## STAFF RECOMMENDATION 1305 Gallatin Avenue September 17, 2014

**Application:** Partial demolition; New construction—addition; Setback determination  
**District:** Eastwood Neighborhood Conservation Zoning Overlay  
**Council District:** 06  
**Map and Parcel Number:** 07213040900  
**Applicant:** Jeffrey Stahl  
**Project Lead:** Melissa Baldock, melissa.baldock@nashville.gov

<p><b>Description of Project:</b> Application is to alter and construct an addition to a non-contributing commercial structure. The project requires a setback determination.</p>	<p><b>Attachments</b> <b>A:</b> Site Plan <b>B:</b> Elevations</p>
<p><b>Recommendation Summary:</b> Staff recommends approval of the project with condition that staff approve a brick sample, and the location of the HVAC units and other utilities. With this condition, staff finds that the project meets Sections II.B.1., II.B.2., and III.B.2. of the <i>Eastwood Neighborhood Conservation Zoning Overlay: Handbook and Design Guidelines</i>.</p>

ELEVATIONS  
**A-4a**

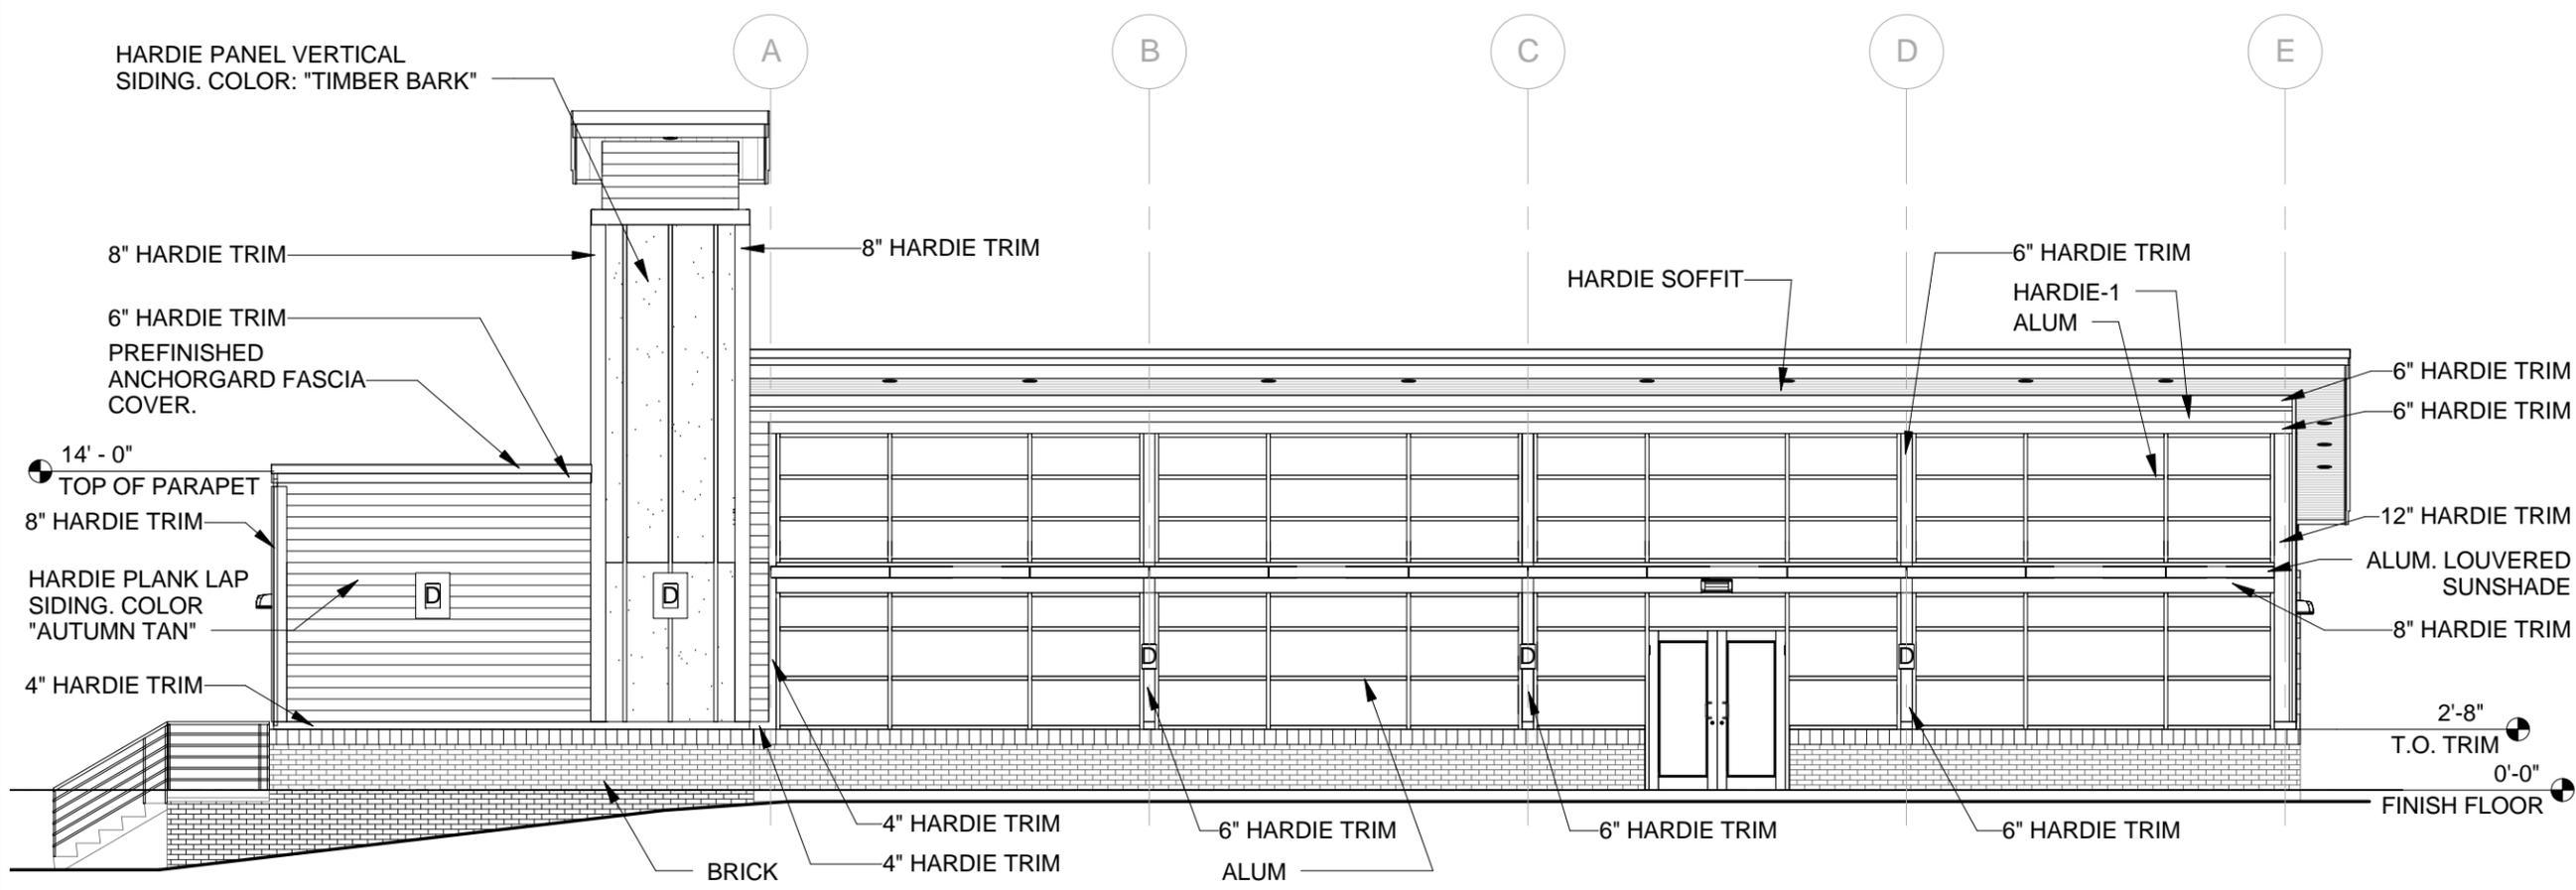
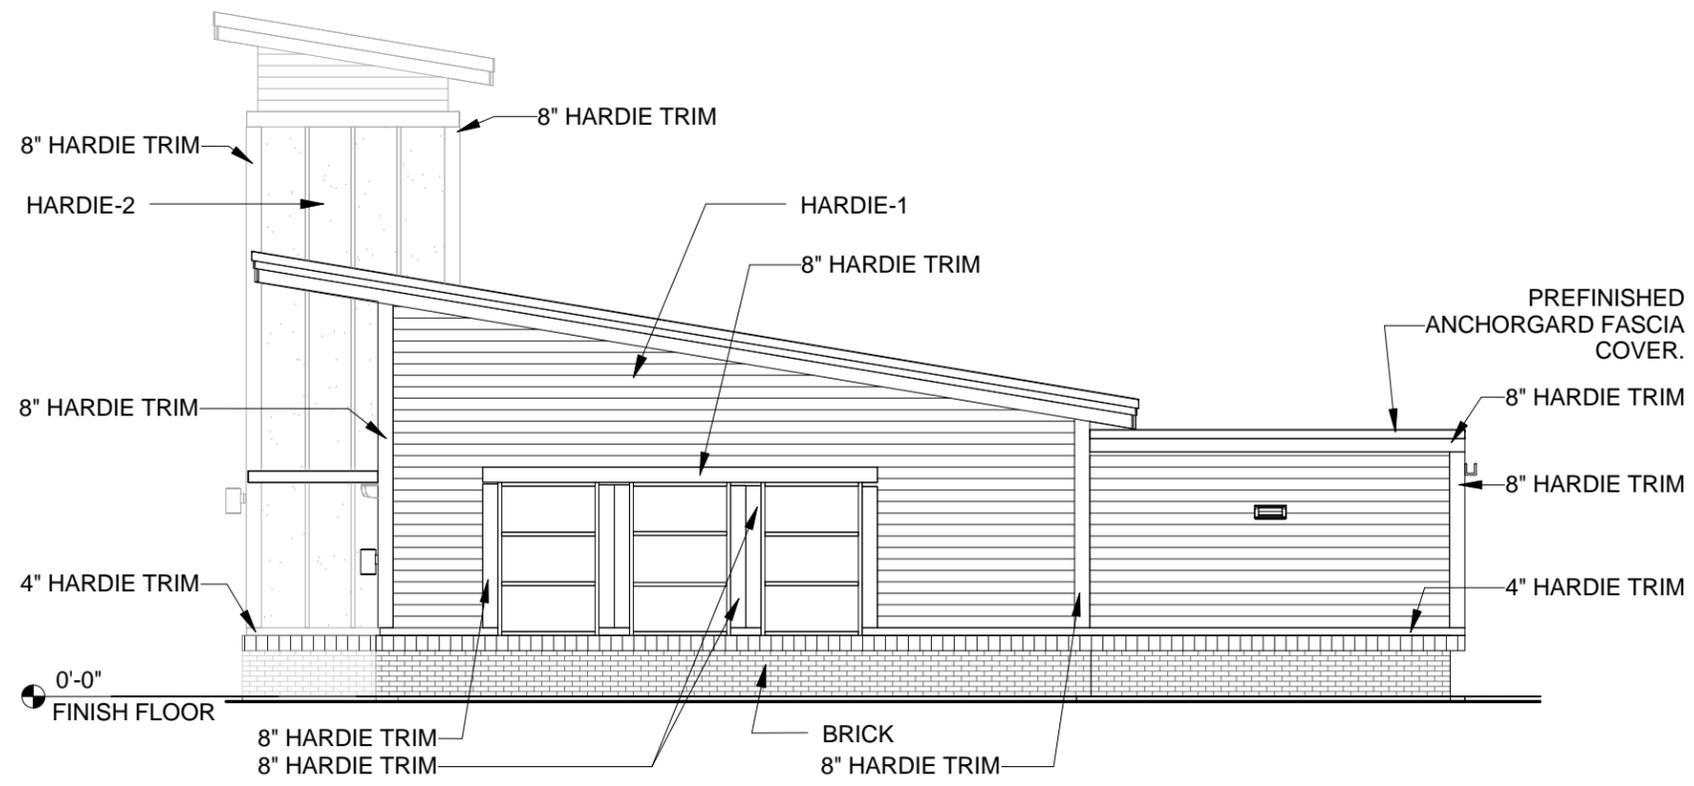
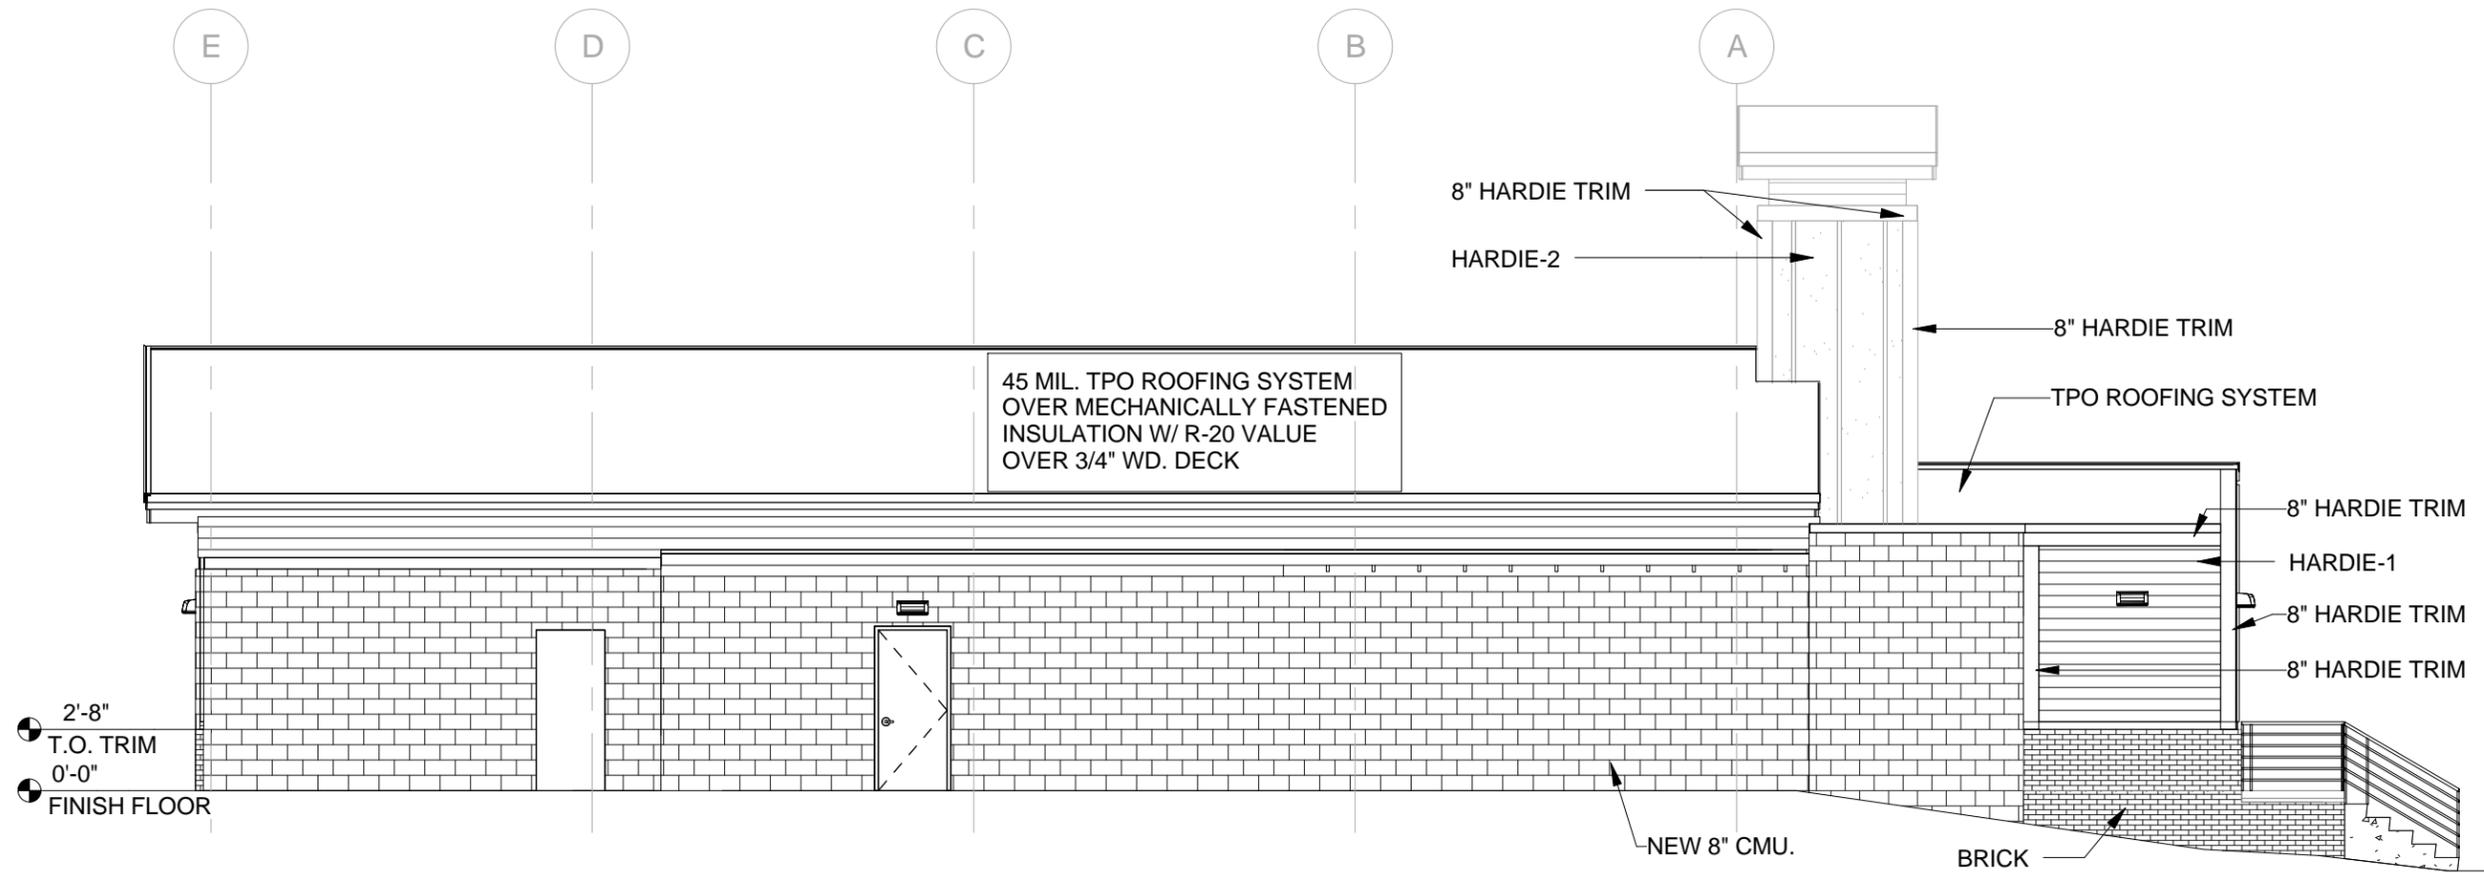
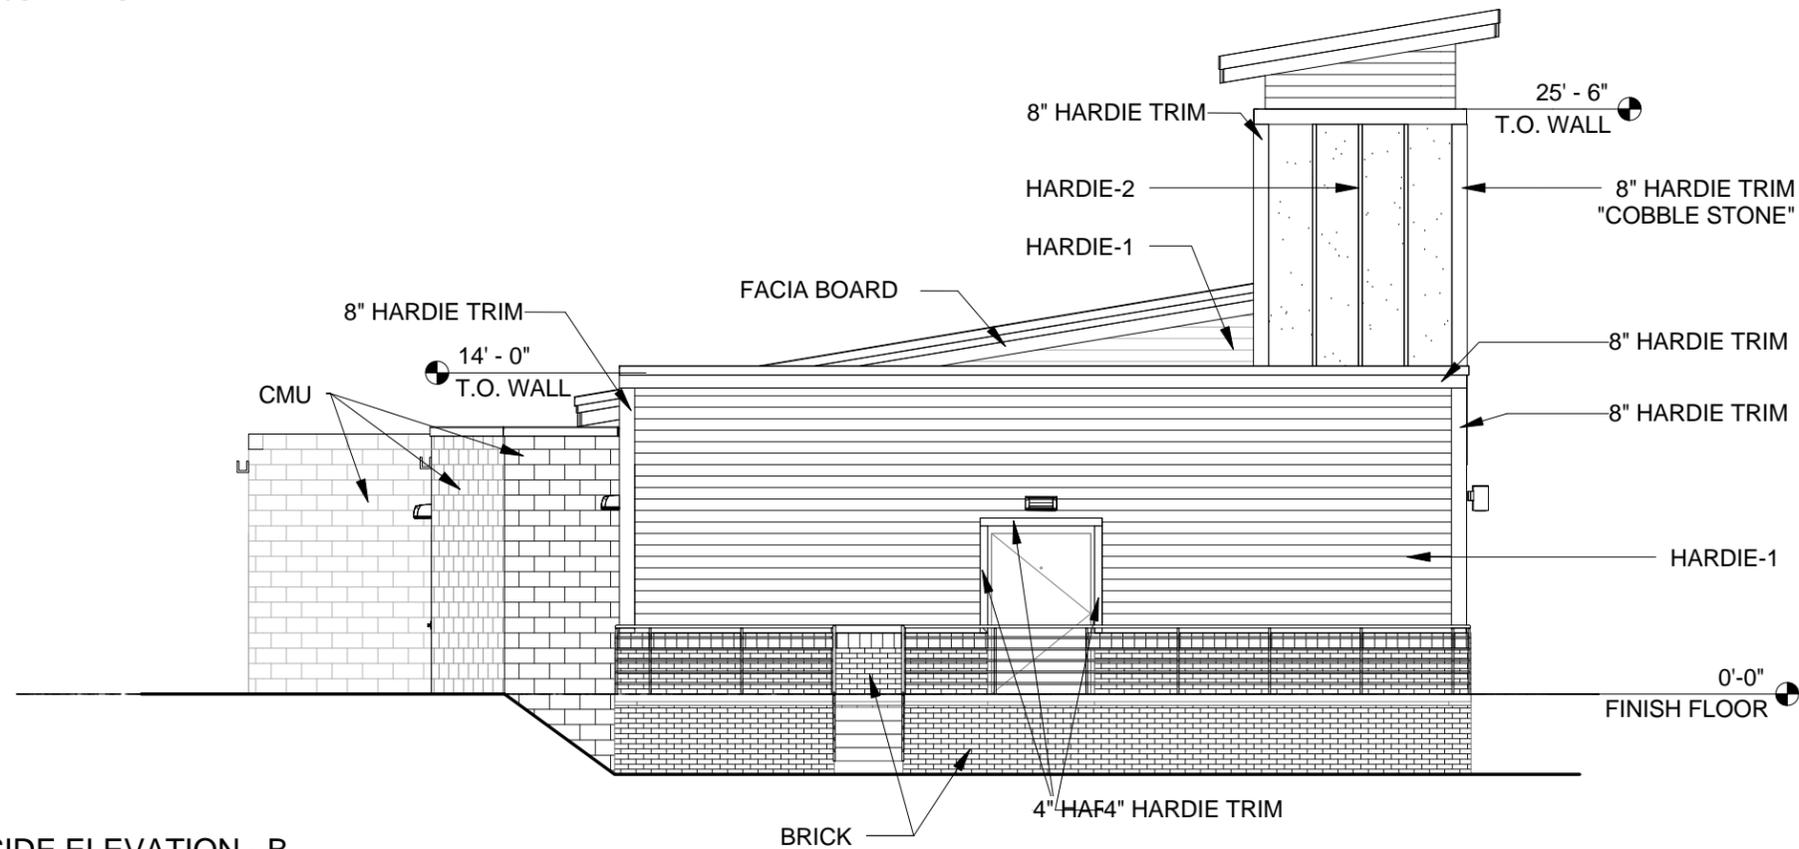
Height & Scale: The redesigned structure will increase the height of the existing structure, but the new height and scale will be appropriate for a commercial structure facing Gallatin Avenue. The main portion of the structure will be approximately eighteen feet (18’) tall at the front facing Gallatin Avenue, with a projecting shed awning that will be approximately twenty feet (20’) tall. A tower element will be added towards the north end of the structure, located away from the historic residential neighborhood. It will be approximately thirty-one feet (31’) tall and seven feet (7’) wide. At the rear, the building’s depth will be extended by approximately sixteen feet (16’) with a one-story extension. The width of the structure along Gallatin Avenue will not change. Staff finds that the redesigned structure’s height and scale are appropriate for a commercial structure facing a non-residential street like Gallatin Avenue, and meet Section II.B.1.a. and b. of the *Eastwood Neighborhood Conservation Zoning Overlay: Handbook and Design Guidelines*.

Materials: The existing structure is largely smooth face concrete block. Much of the existing structure will be re-clad with cement fiberboard siding, cement fiberboard panels, and cement fiberboard trim. The siding will have a reveal of six inches (6”), which is larger than what the Commission typically approves for residential new construction. However, staff finds the six inch (6”) reveal to be appropriate because this is a non-contributing commercial structure that is oriented to face a major commercial thoroughfare rather than a residential street. The larger reveal will help set the structure apart from the residential neighborhood. The windows will be aluminum storefront windows, which are appropriate for a commercial structure like this one. The foundation will be brick, and staff asks to approve the brick color. The Gallatin Avenue façade includes an aluminum sun shade. The roof will be a rubber membrane/TPO roof, which is appropriate for flat and low-sloped roofs on a commercial structure like this building. The rear of the structure will be concrete block, as is existing. With the staff’s final approval of a brick sample, staff finds that the project’s materials meet Section II.B.1.d. of the *Eastwood Neighborhood Conservation Zoning Overlay: Handbook and Design Guidelines*.

Roof form: The main portion of the structure will have a shed roof with a slope of 2/12. Portions of the rear and the northern-most portion of the structure will have a flat roof. Staff finds that these roof forms are appropriate for a commercial structure, particularly one facing a commercial thoroughfare like Gallatin Avenue. Staff finds that the structure’s roof form meets Section II.B.1.e. of the *Eastwood Neighborhood Conservation Zoning Overlay: Handbook and Design Guidelines*.

Proportion and Rhythm of Openings: The Gallatin Avenue façade will be primarily glazing, which is appropriate for a commercial structure. The design does include windows along the Douglas Avenue façade, which faces the residential portion of the conservation overlay. The rear and northern facades have no window openings. Staff finds the project's proportion and rhythm of openings to be appropriate for a commercial structure and to meet Section II.B.1.g. of the *Eastwood Neighborhood Conservation Zoning Overlay: Handbook and Design Guidelines*.

Staff recommends approval of the project with condition that staff approve a brick sample, and the location of the HVAC units and other utilities. With this condition, staff finds that the project meets Sections II.B.1., II.B.2., and III.B.2. of the *Eastwood Neighborhood Conservation Zoning Overlay: Handbook and Design Guidelines*.
